VIP Peak East – Application Reference - 2019/101

Response to HE and BMBC comments on CTMP and Access Drawings

Figure 1: Highest average hourly HGV traffic generation (8:00-9:00 and 17:00-18:00)

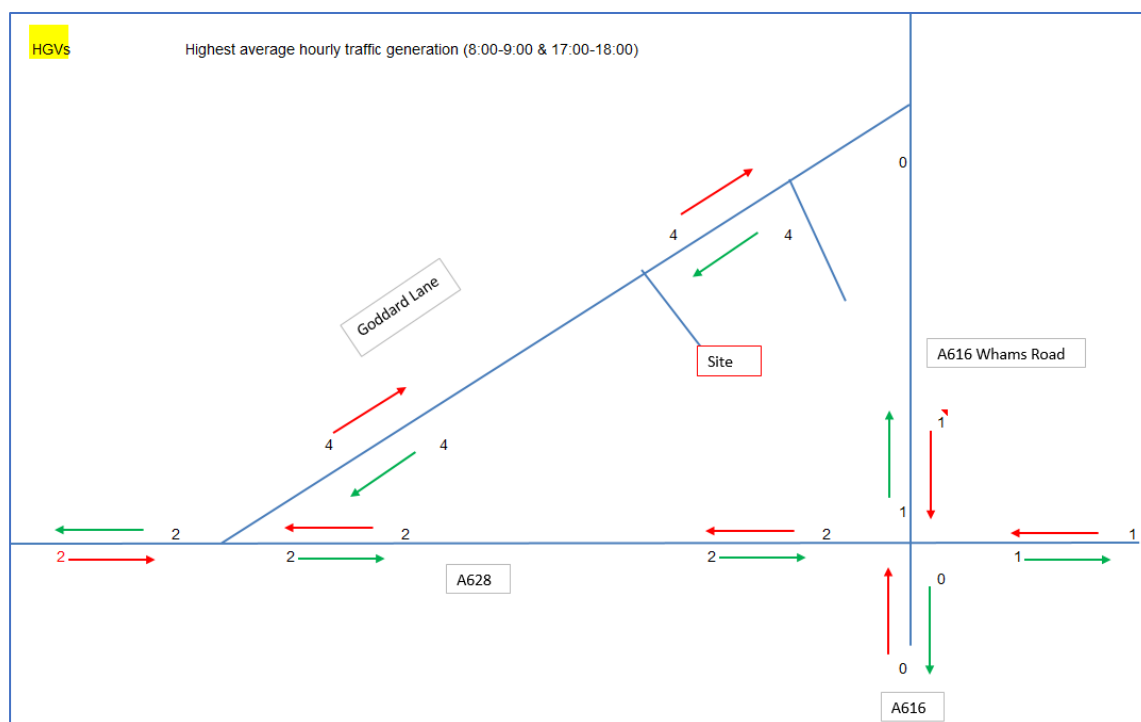
1. Need to include A616 as well as the Flouch Roundabout within the study area.

The highest average hourly HGV and LGV traffic generated by the construction works on the local traffic network is illustrated in Figure 1 and 2 below. The quantum of trips forecast at the Flouch Roundabout is not material enough to necessitate a detailed assessment of the Flouch Roundabout. It should be noted that the average hourly flows presented below are based on flows from the month with the highest predicted monthly two-way flows over the construction duration, and therefore represent a worst case scenario. The typical average hourly flows over the rest of the construction period are therefore likely to be less than those presented.

The predicted maximum hourly construction traffic illustrated in Figure 1 and 2 is not material enough to warrant any junction assessments. No further assessments are therefore proposed.

Figure 5 – 24-hour average daily traffic profile on the A628

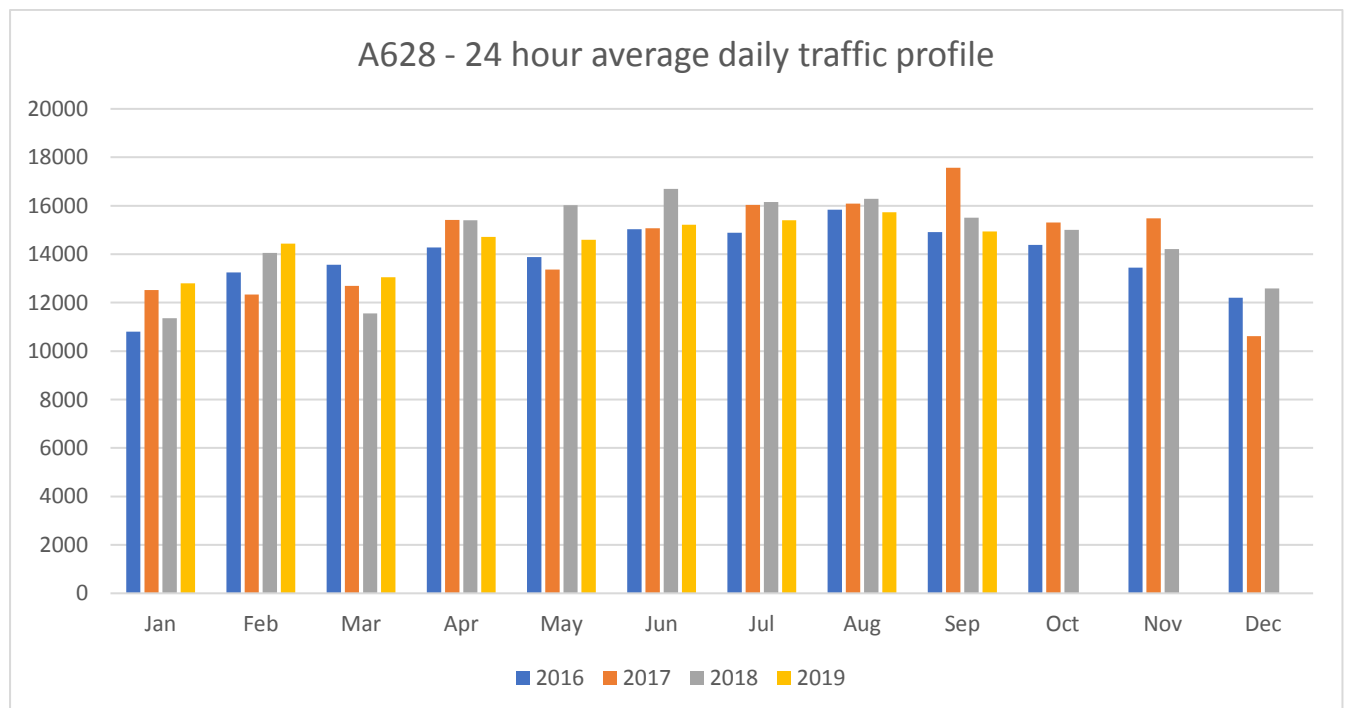
2. Suitability of 2016 (August) traffic data for assessment purposes

Use of traffic data of less than 4 years old is typically considered as acceptable within the transport planning discipline, unless traffic flows change significantly due to a range of location specific factors. Paragraph 8.1.1 of WebTAG unit M3-1 states that trip ends within the 'Fully Modelled Area' derived from traffic data which are less than six years old is deemed acceptable, which further reinforces the rationale for using traffic data obtained in the latter part of 2016.

Notwithstanding the above, an analysis has been undertaken of the daily flow patterns on the A628 between 2016 and 2019 to establish any daily variation in flows. The outcome of this analysis is illustrated in Figure 3. The analysis is based on data obtained from WebTRIS sites 30361361 and 30361360 for the respective years. Figure 5 demonstrates that average daily traffic flows on the A628 have remained fairly consistent between 2016 and 2019. August flows in particular have seen little or no variation across the years under consideration.

In light of the above, the 2016 traffic data is considered robust enough to form the basis of the assessments presented in the traffic chapter of the EAR.
